Name of Project: Kingsley Square Parking Expansion

**RE: COMPLETENESS REVIEW
KINGSLEY SQUARE PARKING EXPANSION
SITE PLAN AND VARIANCE RELIEF
BLOCK 18.03, LOT 18
BOROUGH OF FREEHOLD, MONMOUTH COUNTY, NEW JERSEY**

**RE: KINGSLEY SQUARE PARKING LOT EXPANSION
ENGINEERING REVIEW
SITE PLAN AND VARIANCE RELIEF
BLOCK 18.03, LOT 18
BOROUGH OF FREEHOLD, MONMOUTH COUNTY, NEW JERSEY**

PARKING LOT EXPANSION & GRADING PLAN
TAX LOT 18 BLOCK 18.03
PROJECT NO. 18-03
DATE: 3/27/79
SCALE: 1" = 50'
SHEET: 1 OF 1
JOB NUMBER: 2026

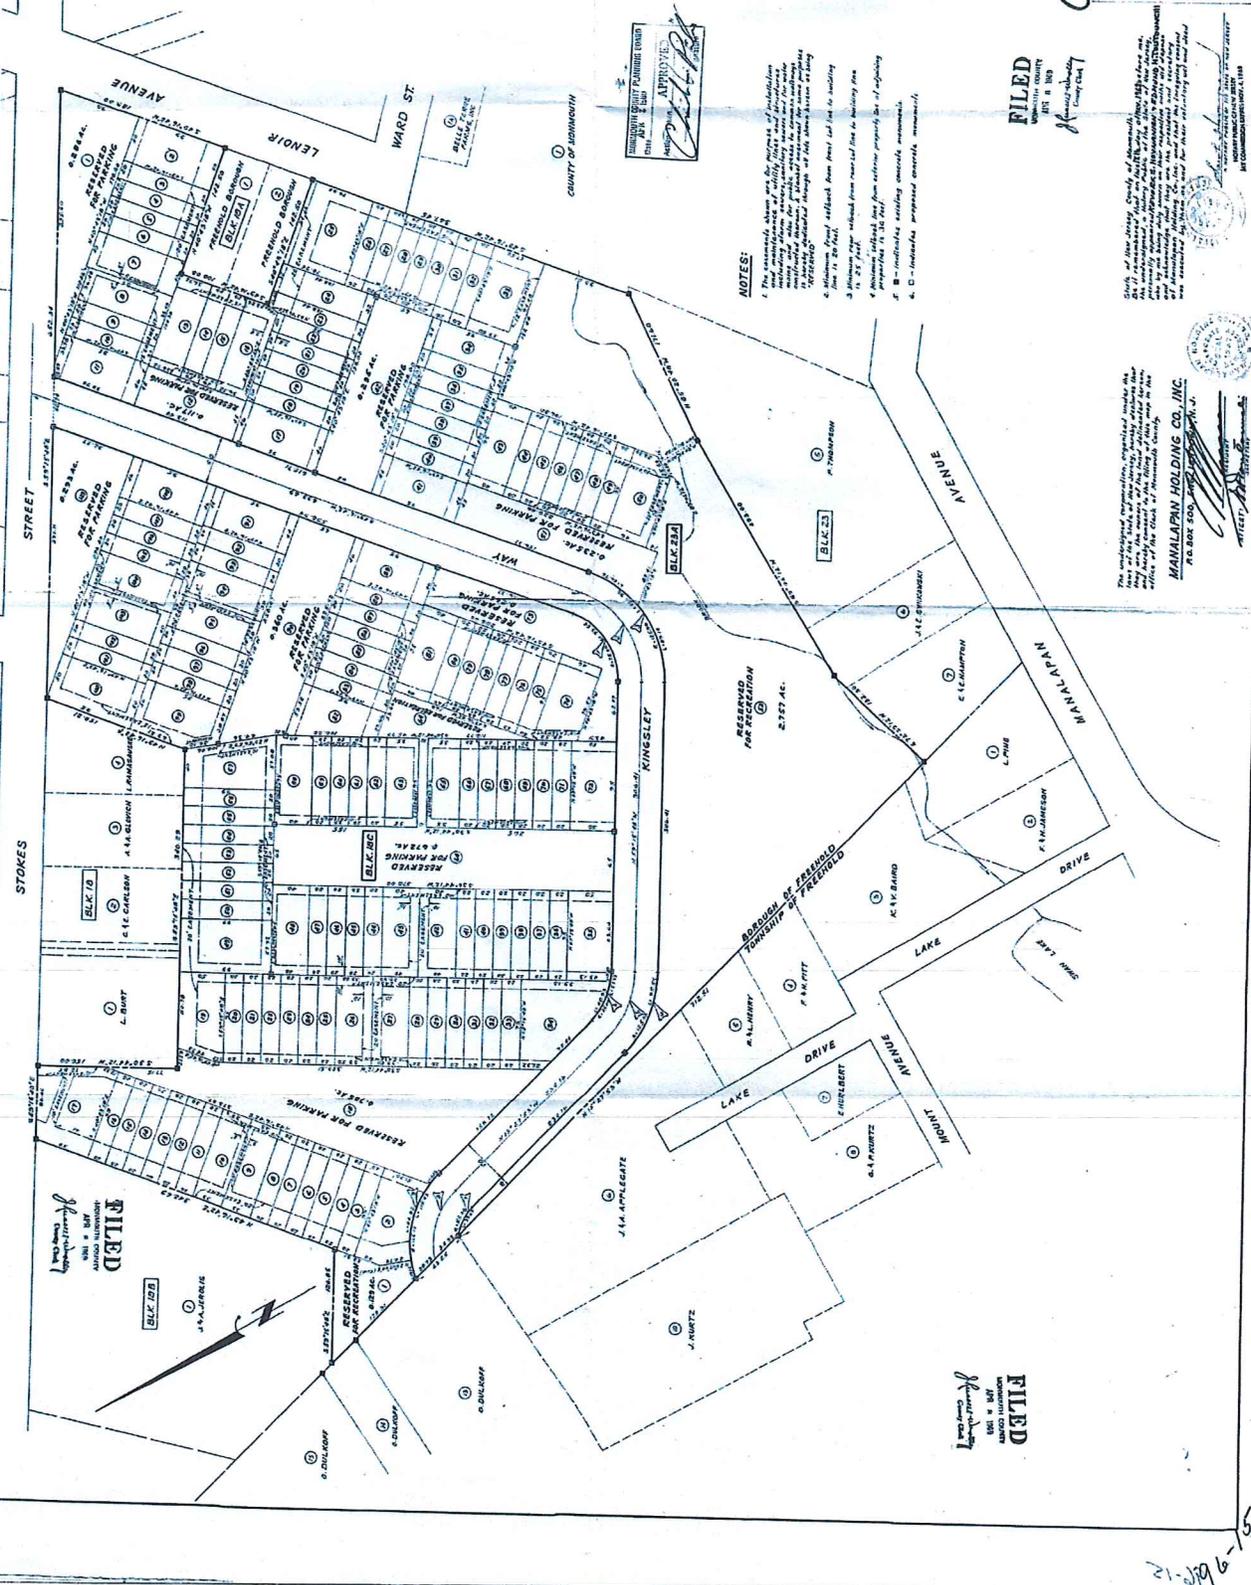
1. The plan indicates an existing Kingsley Square sign within the landscape island, outside the area of proposed additional parking.
2. The documents do not indicate any revisions to existing signage, or any proposed signage. This should be confirmed by the applicant.

1. The Planning Board Application form, under item #11, indicates a request for an amendment or revision to an approved site plan. No information regarding previous approval(s) has been received by this office. The applicant should discuss this with the Board.
2. The Site Plan Application Form, under item #4 would indicate that 10 parking spaces are proposed, whereas the plans depict 9 proposed parking spaces. The number of parking spaces proposed should be clarified with the Board.
3. The width of the existing drive aisles should be indicated on the plan.

4. The plans indicate a portion of pavement in the existing drive aisle is to be regraded to accommodate grading for the proposed new parking pavement. The plans indicate this area to be milled and replaced with 2 inches of bituminous surface course. Notation should be added to the plan indicating that areas of new pavement overlay subject to review and approval of the Engineer's Office in the field prior to construction.
5. The plans do not indicate proposed sidewalks. This should be confirmed by the applicant.
6. Per §8.57, a Major Development is defined as disturbing one or more acres of land. The plan indicates the total area of disturbance is 0.11 acres (4,875 s.f.), which is below the threshold of a Major Development.
7. It is noted the referenced Final Subdivision Map indicates the lot line of Lot 18, and surrounding lot lines.

1. Per §16.24.030.A.13, the minimum front yard shall not be used for off-street parking. In the T-H Townhouse Zone, the front yard setback is 20 feet. The plan indicates proposed parking to within approximately 3 foot of the Kingsley Way right-of-way. Design waiver required.

1. The plan indicates the existing area generally flows in a southwesterly direction. The plans would indicate that the existing overall grading pattern will be maintained with the proposed improvements.

1. The plan indicates the removal of a 24 inch tree as part of the improvement. No new landscaping is proposed. Consideration should be given to provide additional landscape plantings, due to the tree removal, along with appropriate details.

1. The plan indicates 4 existing lights around the area of the proposed additional parking spaces. No further information regarding lighting is indicated.
2. The applicant should review with the Board adequacy of lighting in the area of the proposed parking spaces.
